Project	<b>IEEE 802.16 Broadband Wireless Access Working Group</b> < <a href="http://ieee802.org/16">http://ieee802.org/16</a> >	
Title	<b>Action items from Session #44</b>	
Date Submitted	<b>2006-09-25</b>	
Source(s)	Paul Piggin NextWave Broadband Inc. 12670 High Bluff Drive San Diego CA 92130	Voice: 858 480 3100 Fax: 858 480 3105 <a href="mailto:ppiggin@nextwave.com">ppiggin @ nextwave.com</a>
Re:	Working Group Review of Working Document 802.16h-06/015r1	
Abstract	This document contains a resolution of action items assigned during Session #44.	
Purpose		
Notice	This document has been prepared to assist IEEE 802.16. It is offered as a basis for discussion and is not binding on the contributing individual(s) or organization(s). The material in this document is subject to change in form and content after further study. The contributor(s) reserve(s) the right to add, amend or withdraw material contained herein.

## Action items from Session #44

**Figure 1** Flowchart showing generic operation in bands with specific spectrum users.

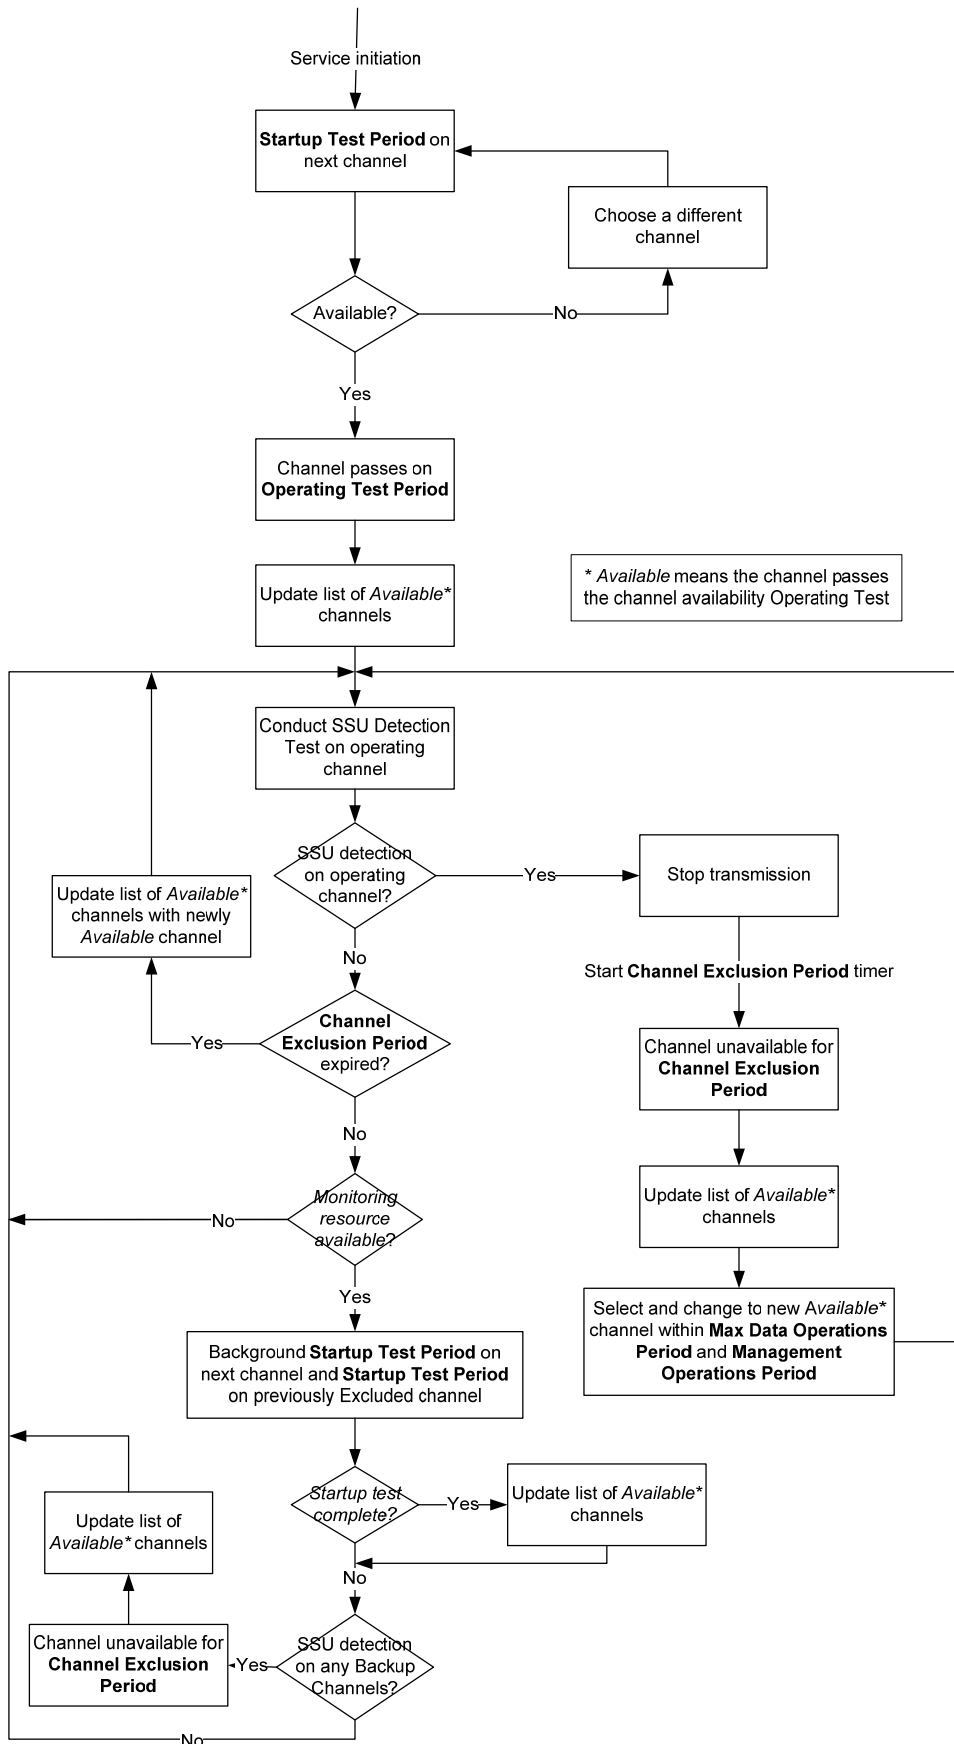
### 3. Correction to figure h1 in 6.3.15 [1]

Figure h1 provides an illustrative flowchart of a generic scheme for operation in bands with SSUs. The flowchart highlights the main operational requirements for coexistence and overviews the description in the remainder of this sub clause.

*Figure 1 below provides a replacement figure for Figure h1 in sub clause 6.3.15.1.*

Figure h2 – Representation of *ChannelCentreFrequency* calculation.

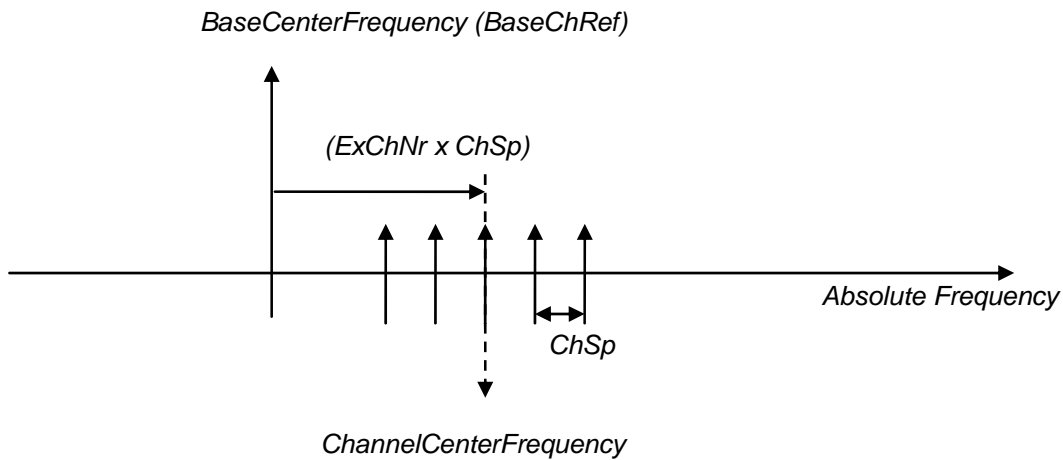
*Replace 6.4.1.2 with the following*

Extended channel numbering provides an enhancement to the definition for *channel center frequency* given in section 8.5.1. This extension provides channel references beyond the limitations of 5-6GHz as defined in that section. The channel references are described according to the following terms.

- Extended Channel Number (*ExChNr*) – A 2 byte specific channel number reference in MHz. *ExChNr* is a logical channel number within a given band and enables the absolute frequency to be calculated with the use of a 2 byte reference.
- Base Channel Reference (*BaseChRef*) – A 1 byte base reference to frequency range or deployment band in MHz. *BaseChRef* is an index into a list of known operational bands, termed *BaseCenterFrequency()*. For a given value of *BaseChRef* then *BaseCenterFrequency()* provides the lowest, or base, center frequency for a particular band of operation.
- Channel spacing (*ChSp*) – A 2 byte channel spacing value in 10kHz increments. The channel spacing is referenced from center frequency to center frequency.

The terms above are used to calculate the physical *channel center frequency*, termed *ChannelCenterFrequency*, and is defined accordingly:

$$\text{ChannelCentreFrequency [MHz]} = \text{BaseFrequency}(\text{BaseChRef}) \text{ [MHz]} + (\text{ExChNr} * (\text{ChSp} * 0.01)) \text{ [MHz]}$$

This is shown graphically in figure h2.
